HISTORIC AND DESIGN REVIEW COMMISSION

February 02, 2022

HDRC CASE NO: 2022-062
ADDRESS: 515 WILLOW ST
LEGAL DESCRIPTION: NCB 1367 BLK 4 LOT 23 BOWDEN ELEMENTARY SCHOOL SUB
ZONING: RM-4, H
CITY COUNCIL DIST.: 2
DISTRICT: Dignowity Hill Historic District
APPLICANT: Terry Palmer/Beaty Palmer Architects
OWNER: SYLVIA PENA/SAN ANTONIO ISD
TYPE OF WORK: Exterior modifications, site modifications, signage, demolition of non-contributing structure
APPLICATION RECEIVED: January 13, 2022
60-DAY REVIEW: Not applicable due to City Council Emergency Orders
CASE MANAGER: Rachel Rettaliata
REQUEST:

The applicant is requesting a Certificate of Appropriateness for approval to:

1 SITE PLAN - OVERALL
1" = 30'-0" EXISTING / SELECTIVE DEMOLITION

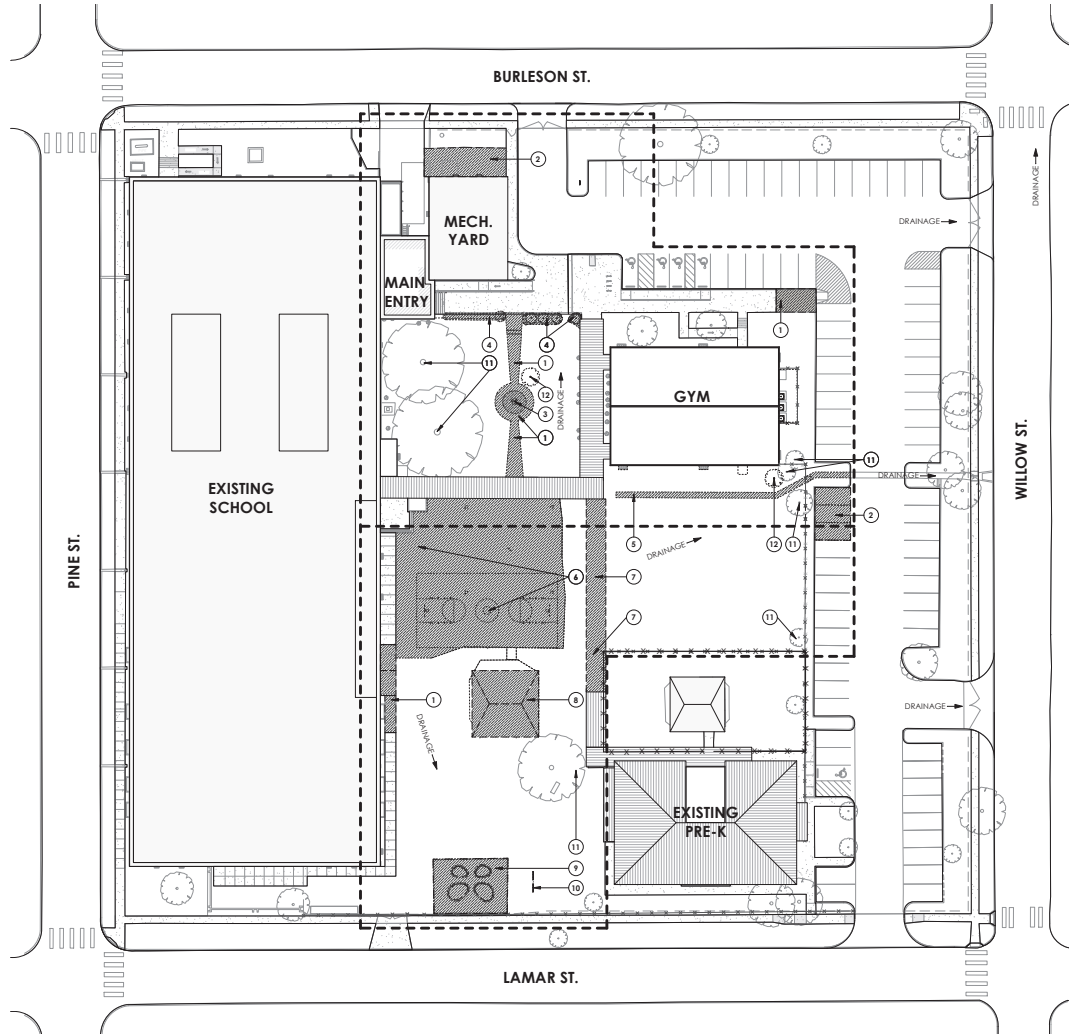
- b. **CANOPY DEMOLITION** – The applicant has proposed to remove a portion of the existing walkway canopy and associated concrete footing that is oriented north-south, located between the gymnasium and the existing pre-k building, adjacent to the existing basketball court. The canopy structure features a metal roof and metal posts. The applicant has proposed to remove the existing canopy structure to accommodate new landscaping for the proposed new common outdoor recreation area. Guideline 11.A.i. for Exterior Maintenance and Alterations states that existing historic awnings and canopies should be preserved. According to the Historic Aerial Maps, the existing walkway was installed after 1995. As the existing canopy is not a contributing structure, staff finds the proposal appropriate.

1 ENLARGED PLAN - PLAYGROUND EQUIPMENT
3/16" = 1'-0"

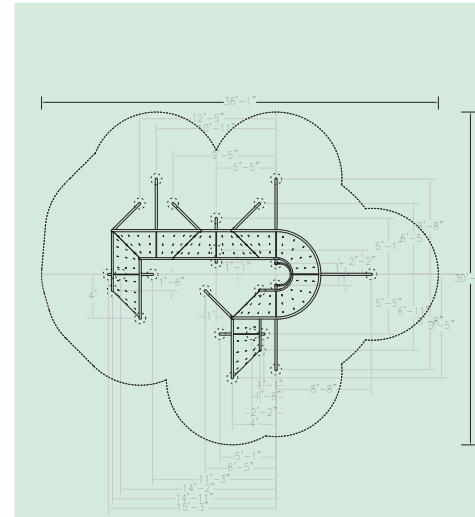
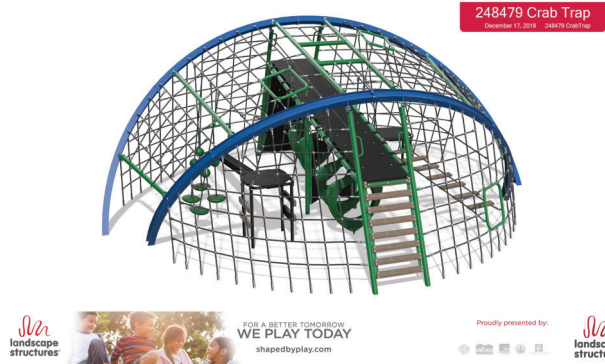
- f. **PLAYGROUND EQUIPMENT** – The applicant has proposed to install new playground equipment in the entry courtyard to the west of the gymnasium and in the common outdoor recreation area to the west of the existing pre-k building. The applicant has proposed to replace the existing shade structures with shade sail structures and install a Crab Trap and Mobius Climber. Staff finds the proposal appropriate.

4 EXTERIOR ELEVATION - SOUTH
1/8" = 1'-0" EXISTING / NEW CONSTRUCTION

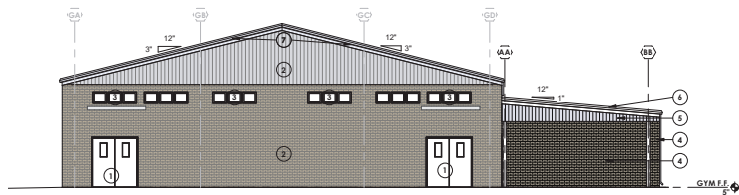
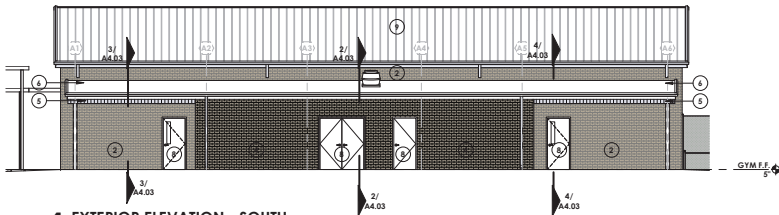
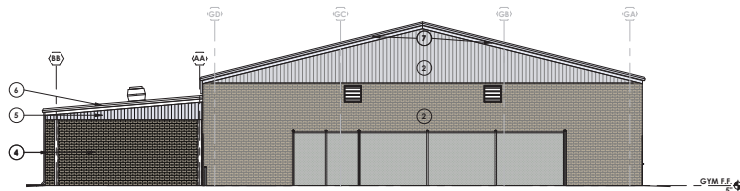
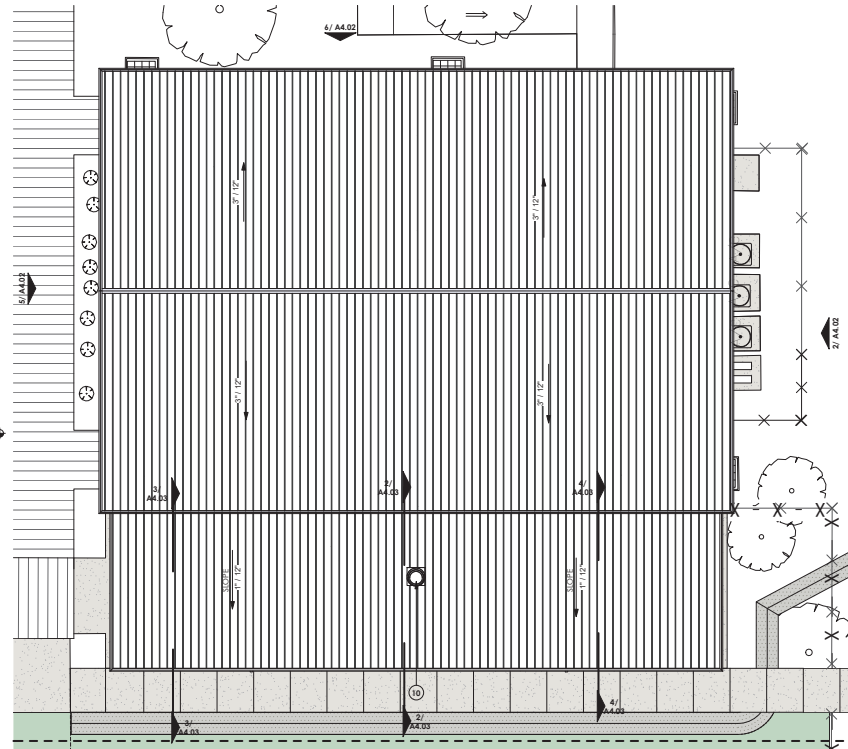
- c. **ADDITION** – The applicant has proposed to construct a 1,762-square-foot addition on the south elevation of the gymnasium building. The proposed 1-story addition will be rectangular in plan and feature a standing seam metal shed roof to match the existing material on the primary structure, brick cladding, and metal wall soffit panel to match existing. The proposed south elevation of the addition will feature two (2) pedestrian doors with lites on the east and west end of the elevation, one (1) set of solid French doors located in the center of the elevation, and one (1) solid pedestrian door to the east of the French doors. No openings are proposed on the east or west elevations of the addition as the addition will accommodate a gymnasium changing room. According to the Historic Design Guidelines, additions should utilize complementary materials and respect the existing structure in terms of scale, massing, and detailing. Staff finds the proposal appropriate.
